Model: Adonis-C2		Date: 10-May-01	No.: MB003001
Modified Article: Operation Panel Ass'y		Prepared by: E. Fukuyama	
From: Technical Services Dept., GTS Division			
Reason for Modification:	☒ Parts catalog correction ☐ To facilitate assembly ☐ Part standardization	☐ Vendor change ☐ To improve reliability ☐ Other	☐ To meet standards ()

Model: Adonis-C2		Date: 07-Jun-01	No.: MB003002
Modified Article: Card Cover		Prepared by: E. Fukuyama	
From: Technical Services Dept., GTS Division			
Reason for Modification:	☐ Parts catalog correction ☐ To facilitate assembly ☒ Parts standardization	☐ Vendor change ☐ To improve reliability ☐ Other	☐ To meet standards ()

Model: Adonis-C2		Date: 04-Jul-01	No.: MB003004
Modified Article: LCD		Prepared by: E. Fukuyama	
From: Technical Services Dept., GTS Division			
Reason for Modification:	☐ Parts catalog correction ☐ To facilitate assembly ☐ Part standardization	☒ Vendor change ☐ To improve reliability ☐ Other	☐ To meet standards ()

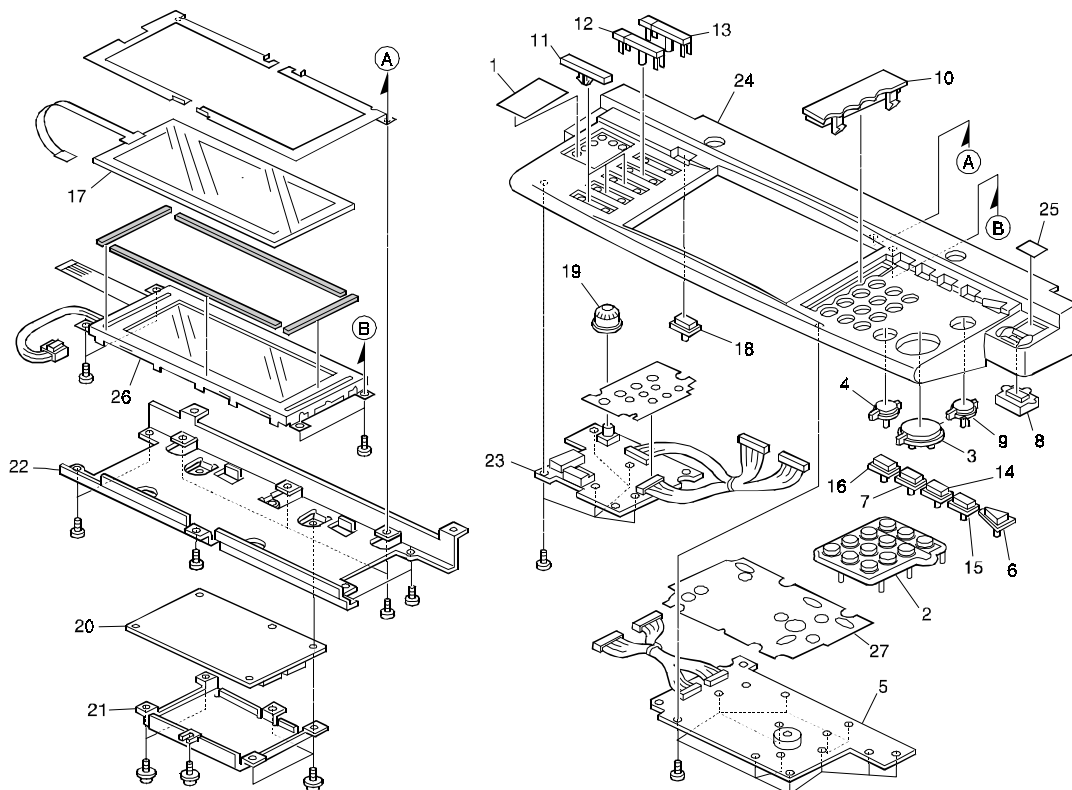
1. Description correction.

Part number	Old description	New description	Page	Index
B0041508	Keytop – Preheat	Keytop - Energy Saver	17	15
B0041510	Keytop – Confirm	Keytop – Check Modes	17	16

2. Parts deletion.

The following part was mistakenly listed in the catalog:

Part number	Description	Q'ty	Page	Index
B0041507	Keytop – Reset Switch	1	17	14

3. Description correction, index number correction (illustration only): 17 → 7.

Part number	Old description	New description	Page	Index
B0041509	Keytop – Block Diagram	Keytop - Program	17	7

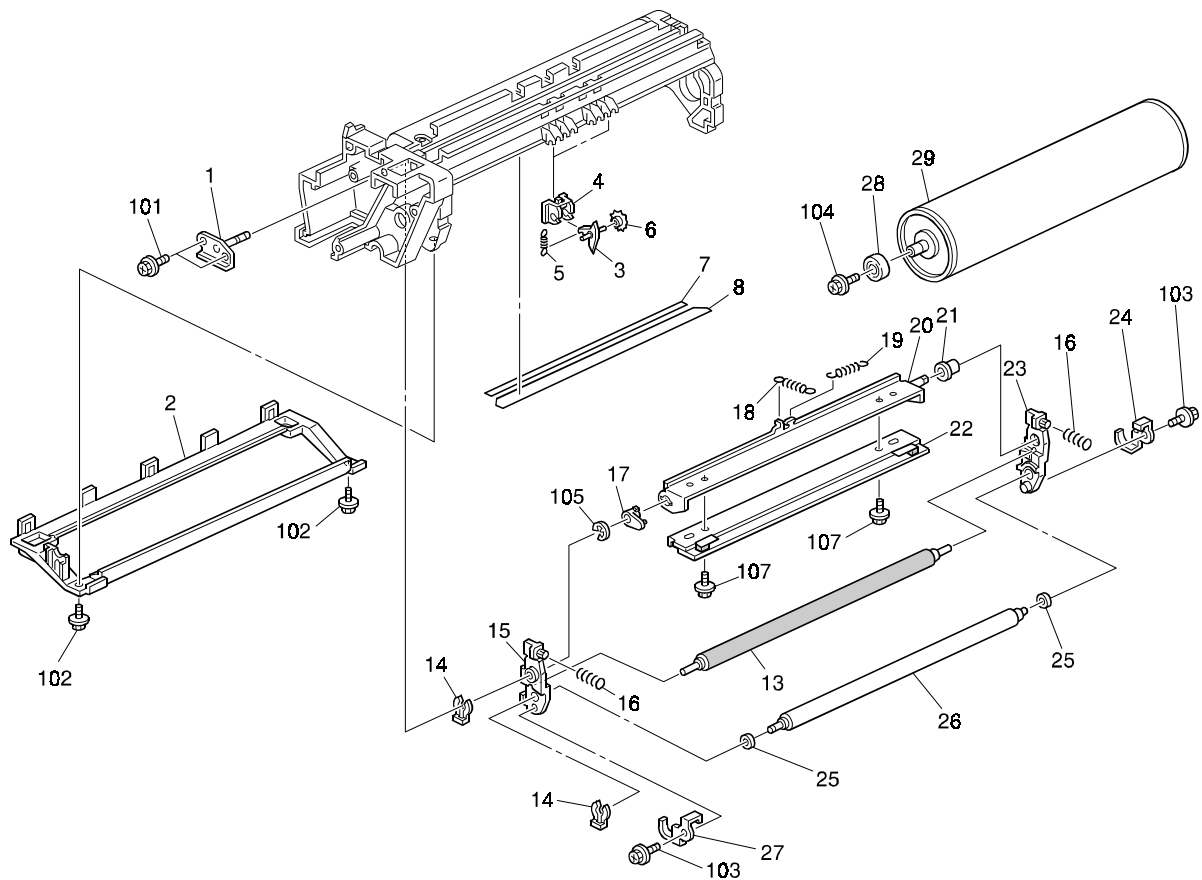
As shown below, the Cleaning Pad has been changed over to a Brush Roller, in order to increase the efficiency of Charge Roller Cleaning. In accordance with this change, the other parts listed below have also been changed.

For machines produced before this modification, either of the following is possible:

1. The Cleaning Pad can be replaced with the new Brush Roller, in which case it is also necessary to replace the parts in the Cleaning Roller Arm Kit (see below), or:
2. The existing Cleaning Pad for the NAD can be used (P/N A2322430).

*1: When installing the new Brush Roller, be sure to also install the Cleaning Roller Arm Kit.

*2: The Cleaning Roller Arm Kit consists of the following parts:

No	Part number	Description	Q'ty
1	G0652321	Front Arm – Charge Unit	1
2	G0652326	Rear Arm – Charge Unit	1
3	AA063648	Pressure Spring	2

Note:

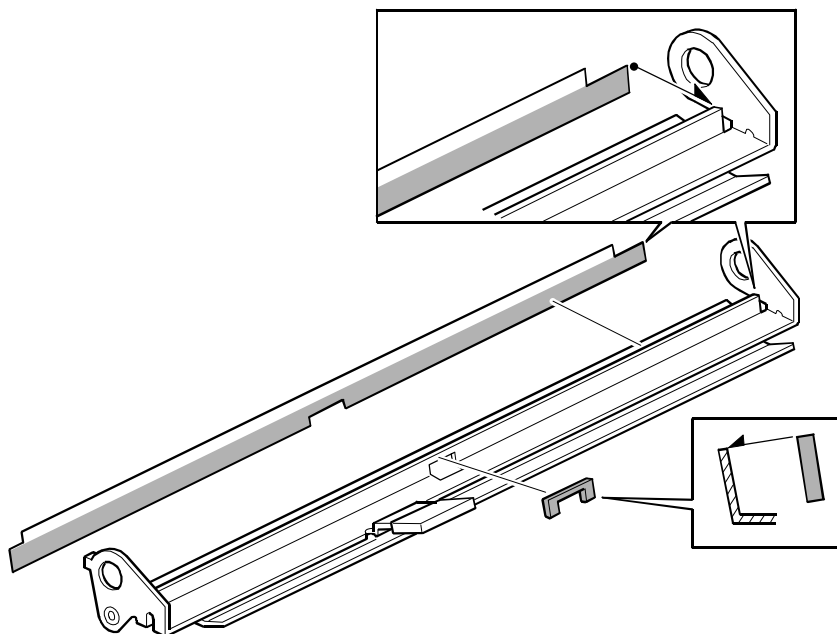
A new Mylar Kit has been registered as a service part to minimize the following two symptoms, which can occur with paper containing a large amount of paper dust. The Mylar will clean the dust off the Registration Roller and reduce the amount that gets mixed in the Development Unit.

1. Dirty background – paper dust adheres to the Transfer Belt Cleaning Blade and inhibits Transfer Belt cleaning.
2. Black spots – paper dust gets into the Development Unit.

1. As shown in the illustration below, the kit is attached to the Upper Entrance Guide (A2322574, P/C pg. 33, #9).
2. When making service visits for machines with the kit installed, please clean any paper dust that has accumulated on the Upper Entrance Guide or paper transport area.

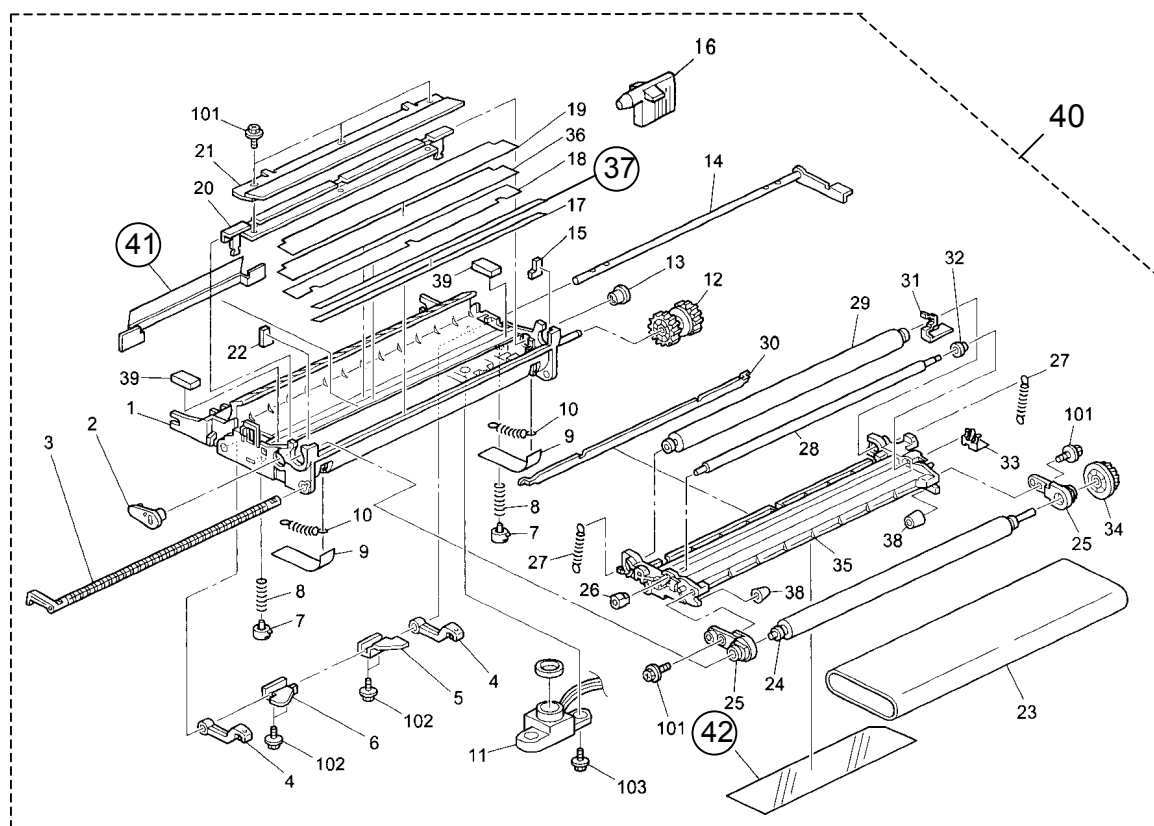
In response to the following symptom, one strip of Mylar has been modified and two have been newly added as shown in the table below.

The rear side of copies is dirty.

When paper dust accumulates on the transfer unit cleaning blade, the blade is not able to effectively clean the toner off the transfer belt. As a result, the toner remaining on the belt is transferred to the rear side of the paper.

1. One strip of Mylar (B0043911) has been added to scrape off the extra toner stuck to the transfer belt surface.
2. With the addition of the B0043911 Mylar, the shape of the entrance Mylar has been modified and its part number has been changed from A2323904 to B0043915.
3. One strip of Mylar (B0043914) has been added to scrape off any toner stuck to the drive roller surface.

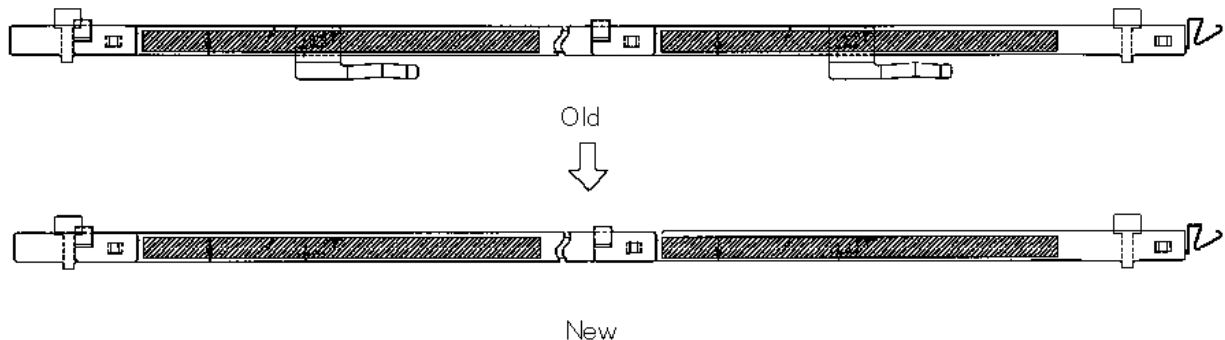
As announced in MB003009, with the changeover to the Brush Roller, one of the parts deleted was the Charge Cleaning Bracket. As a result, the blade spring used to push the Charge Roller Receptacle against the bracket has become obsolete. The blade spring sections have therefore been removed from the Receptacle as shown below.

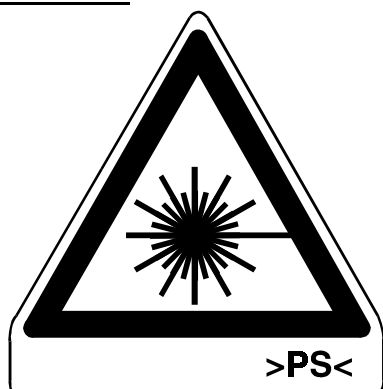
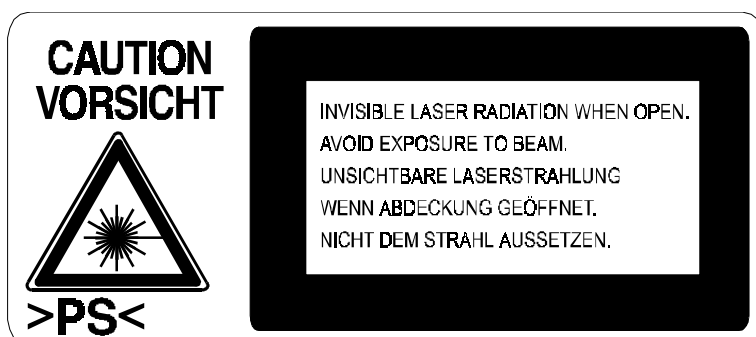
Due to parts standardization, the following two decals have been combined into one (see the illustration).

Old decals:

New (combined) decal:

- Exterior 2 (B003/B004/B006/B007): Page 11
ADD the following parts to index No. 9

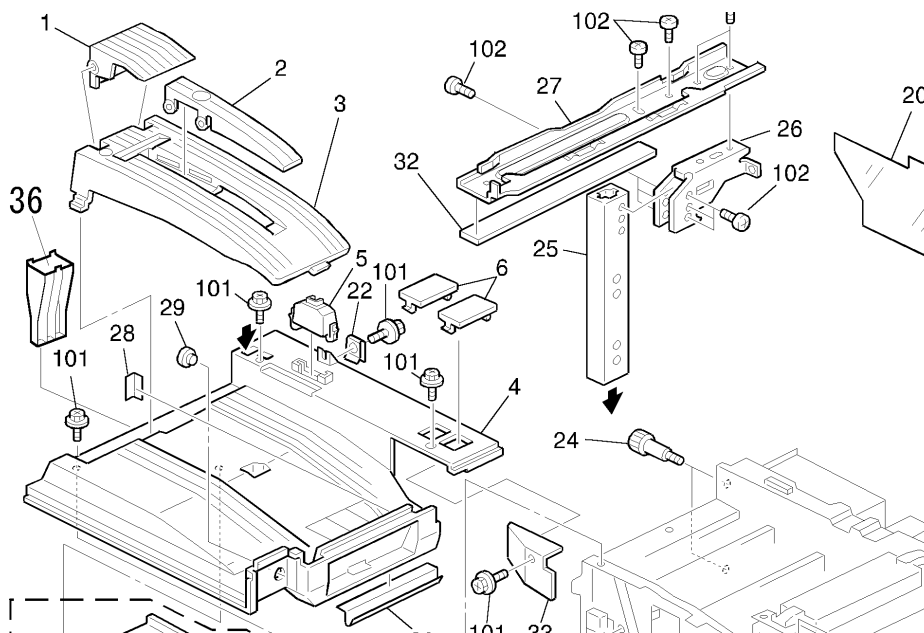
Index No.	Part No.	Description	Q'ty
9	B0037215	Emblem (Nashuatec/B003)	1
9	B0037216	Emblem (Rex Rotary/B003)	1
9	B0047215	Emblem (Nashuatec/B004)	1
9	B0047216	Emblem (Rex Rotary/B004)	1

- Exterior 3 (B003/B004/B006/B007): Page 13

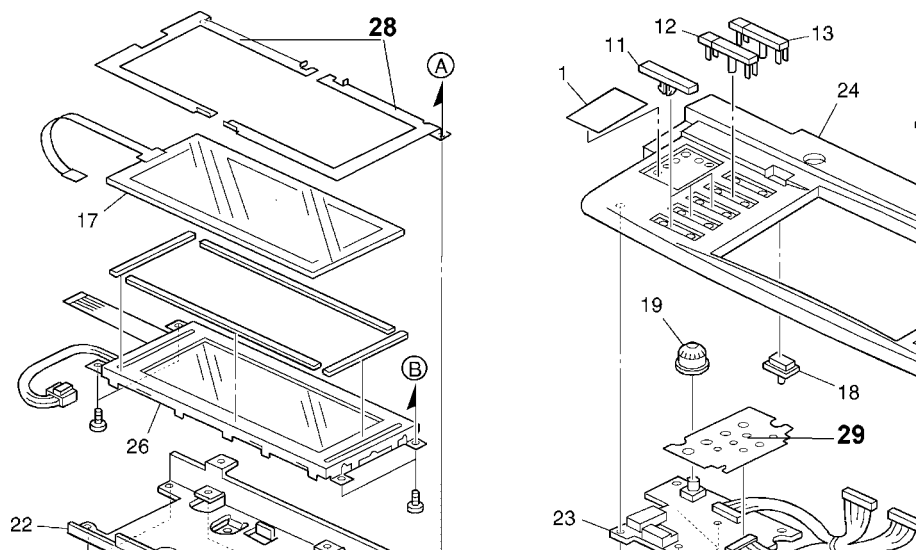
ADD index #36 to the illustration and the information below to the list.

Index No.	Part No.	Description	Q'ty
36	B0041097	Shipping Support - Scanner	1

3. Operation Panel Ass'y (B003/B004/B006/B007): Page 17

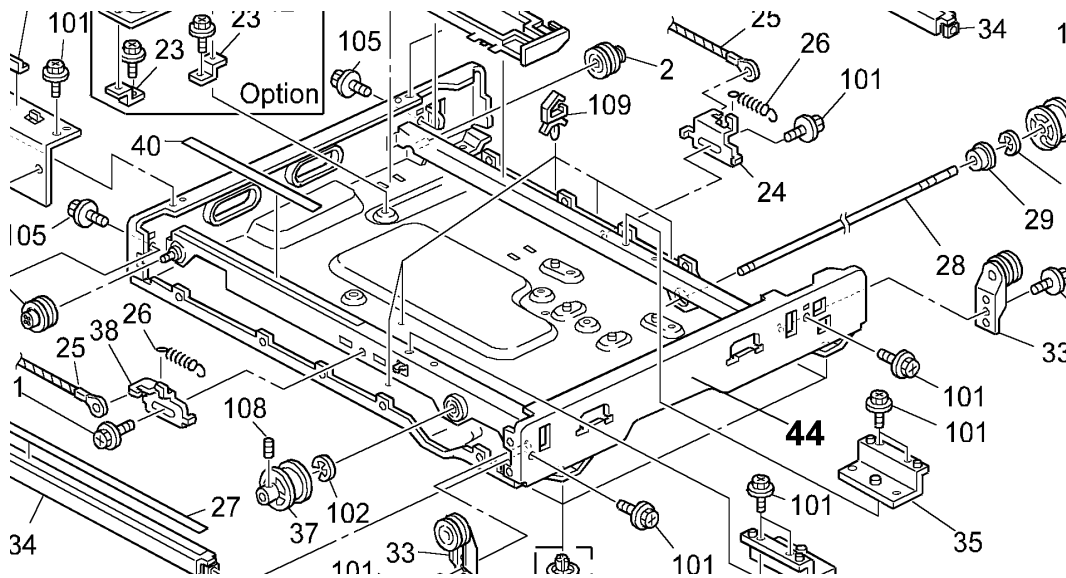
ADD index #28 to the illustration.

ADD index #29 to the illustration and the information below to the list.

Index No.	Part No.	Description	Q'ty
28	B0041517	Earth Sheet – Touch Panel	1
29	B0041516	Sheet – Prevent fence - Left	1

4. Optics Unit (B003/B004/B006/B007): Page 21

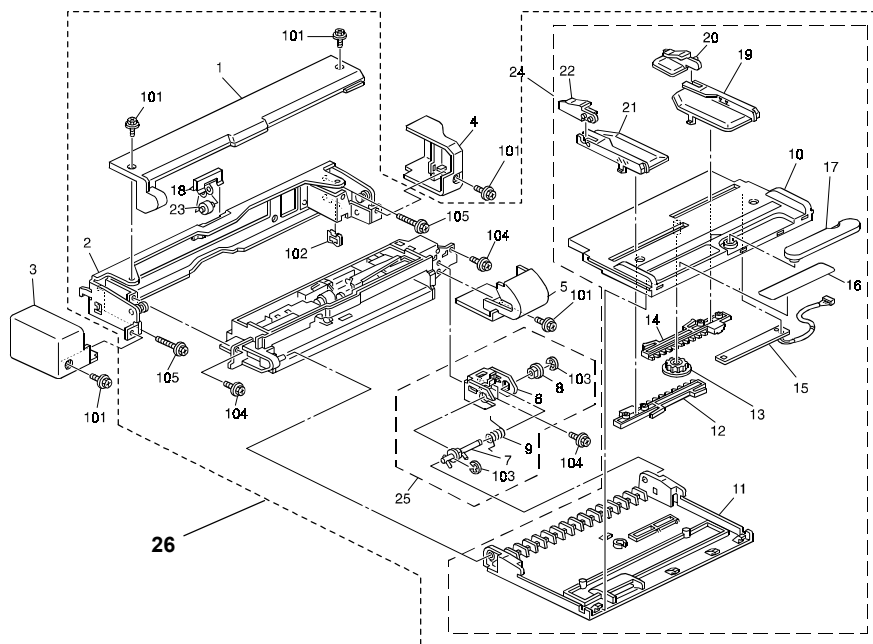
ADD index #44 to the illustration and the following information to the list (newly registered part).

Index No.	Part No.	Description	Q'ty
44	B0041691	Scanner Frame Assy	1

5. By-pass Feed Unit 1 (B003/B004/B006/B007): Page 25

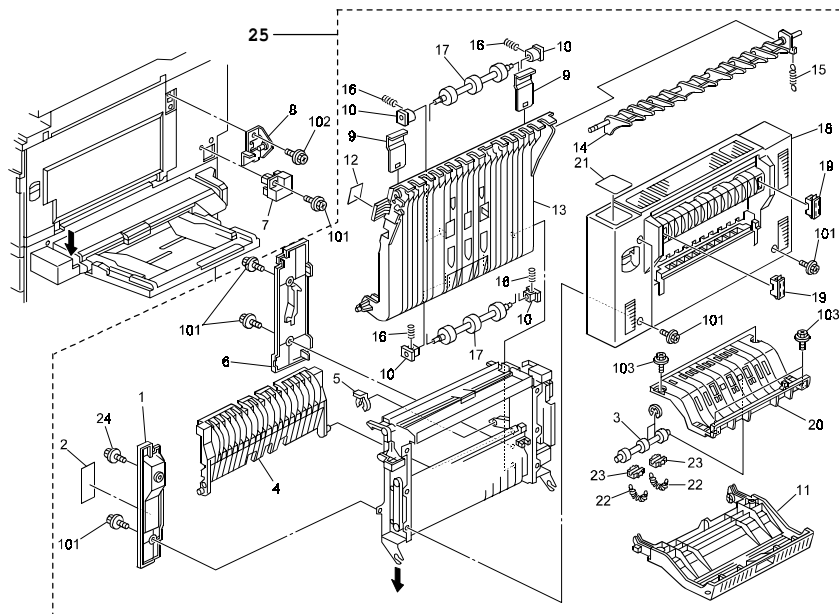
ADD index #26 to the illustration and the following information to the list (newly registered part).

Index No.	Part No.	Description	Q'ty
26	A2326002	By-pass Feed Unit	1

Replacement Procedure for parts modified in section A above

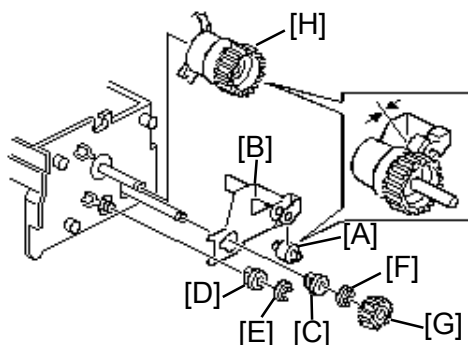
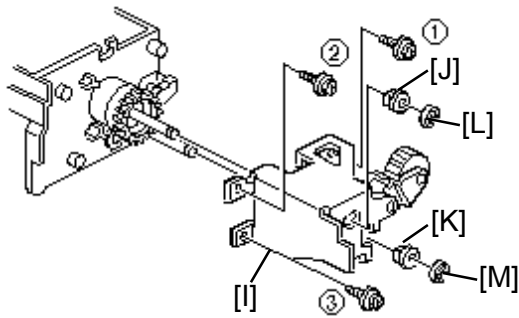
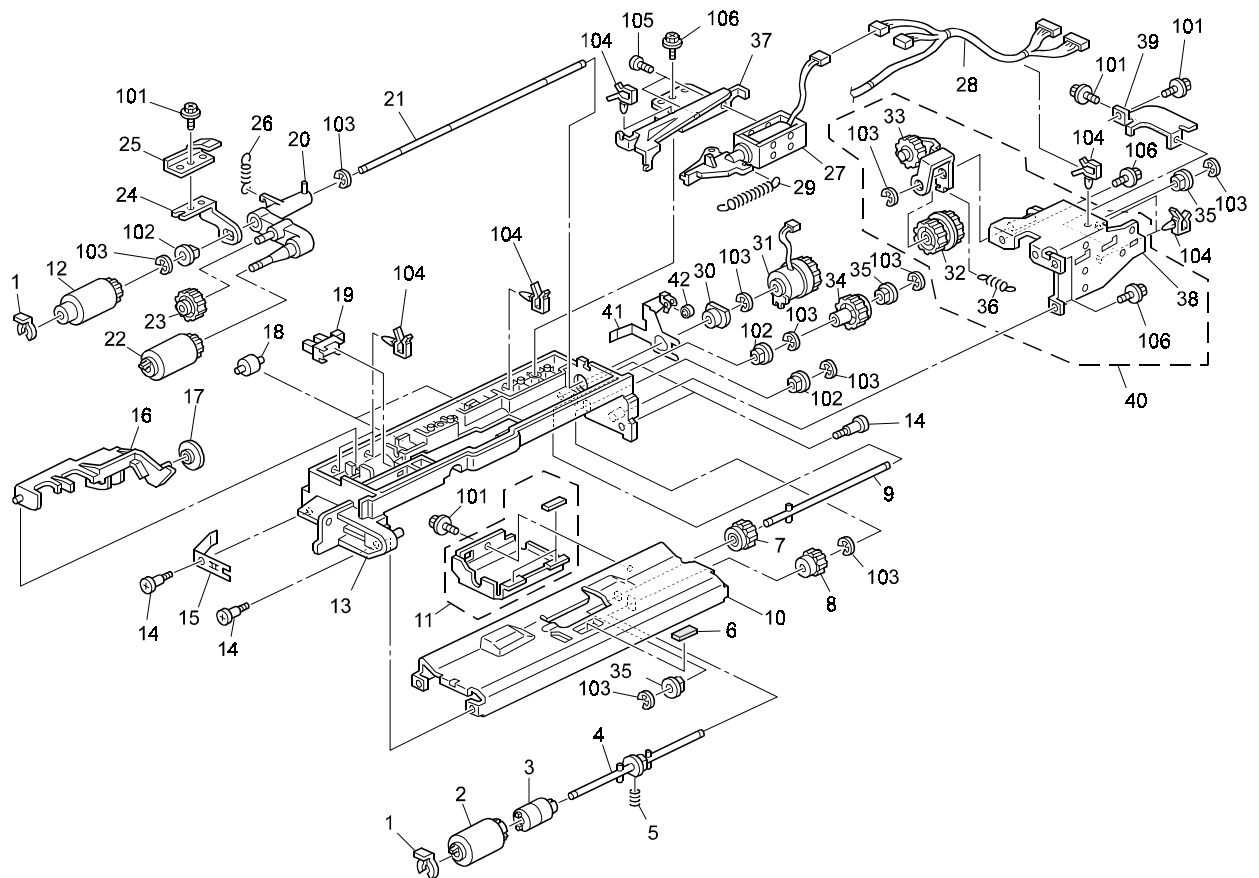
1. Lengthened the Feed Shaft from 229mm to 249mm.
2. Added a Bushing and e-ring.
3. Modified the shape of the Tightener Bracket to accommodate the new bushing (hole added).

1. Added a Roller to be pressed closely against the clutch.
2. Added a Pressure Plate to attach the Roller.

Remove the Tightener Bracket, Retaining Ring, Bushing and Electrical Clutch as shown below.

1. Replace the Feed Shaft with AA140753.

2. Attach the Driven Roller [A] to the Pressure Plate [B], then peel off the outer layers of the double-sided tape (2 places) on the Pressure Plate.
3. Set the Bushing [C] in the hole in the Pressure Plate, then mount the two together onto the Feed Shaft.
Note: Be careful not to let the exposed double-sided tape contact the Side Plate.
4. Set Bushing [D] in the cutout on the side of the Pressure Plate, then push in the Pressure Plate along with the two bushings. After it is set in position, attach e-rings [E] and [F].
5. Press the Pressure Plate firmly against the Side Plate so that the double-sided tape catches and secures the two together.
6. Attach the Gear [G].
7. Attach the Electrical Clutch [H].

8. Remove the Arm Tightener, Gear and Spring attached to the Tightener Bracket removed in the Prep stage above, then attach them to the new Tightener Bracket [I].
9. Attach the Tightener Bracket [I] and Bushings [J] and [K]. Then, tighten the screws in the order shown.
10. Attach e-rings [L] and [M].

Visual distinction:

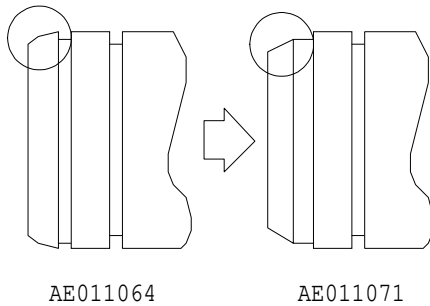
The following hot roller has been changed due to parts standardization.

The old roller (left) contains a groove on the fusing knob end.

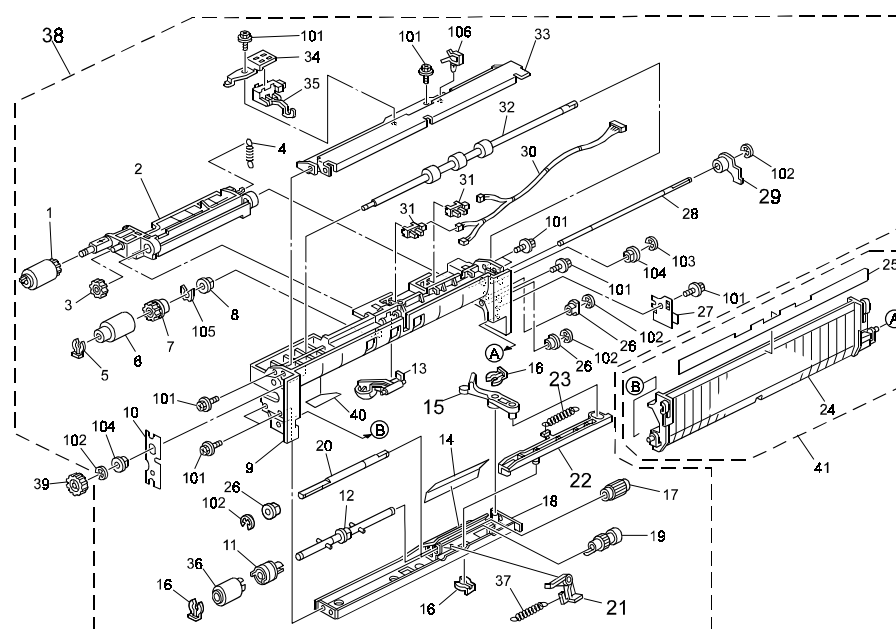
The following have been modified to ensure that the Separation Roller and Feed Roller separate from one another when the tray is pulled out, preventing damage to the paper.

1. Tension Spring: Tension changed.
2. Pressure Lever: Pawl added.
3. One-Way Clutch (Feed Lever): Lever arm added to help rotate shaft when released.
4. Release Lever: Shape changed to support Feed Lever.
5. Link Lever: Position of spring hook changed.
